Technical Bulletin

No. T16.3

IMPORTANT: Clearing History Log causing Device Description Clear on E3 and S3 Series

Figure 1. Affected boards: ILI-MB-E3 (Left), SLC-PM (Right)

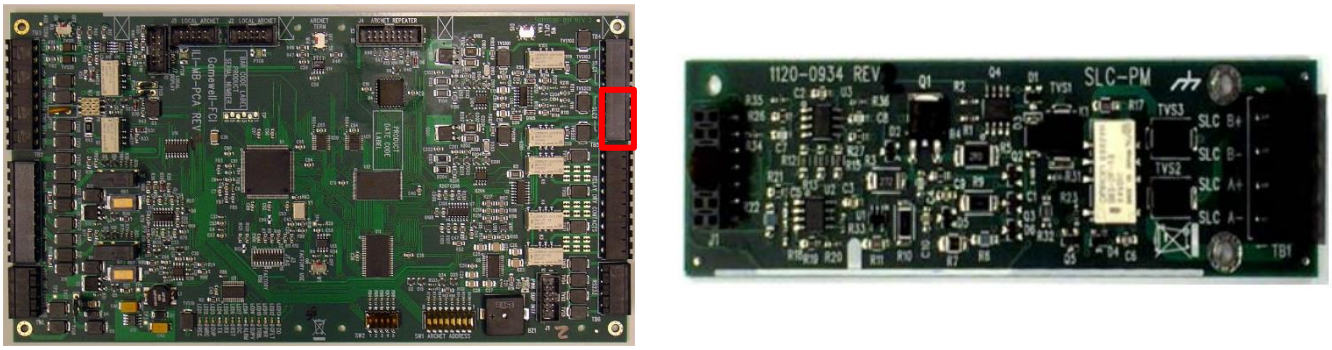
Gamewell-FCI has discovered an issue regarding descriptions being unexpectedly cleared. This issue has been seen on E3 Series running firmware V4.00.14 or later and the S3 Series Fire Alarm Control Panels running firmware V1.13.001 or later. Device descriptions for devices connected on SLC 2 on the ILI-MB-E3 or SLC-PM #2 on the S3 might be cleared when the history log is cleared.

Gamewell-FCI recommends that customers upgrade to the latest firmware (V4.03.190) for the ILI-MB-E3 to resolve this issue on the E3 Series FACP.

Gamewell-FCI is currently working on a firmware fix to address this issue on the S3 Series FACP and will be available at a later date.
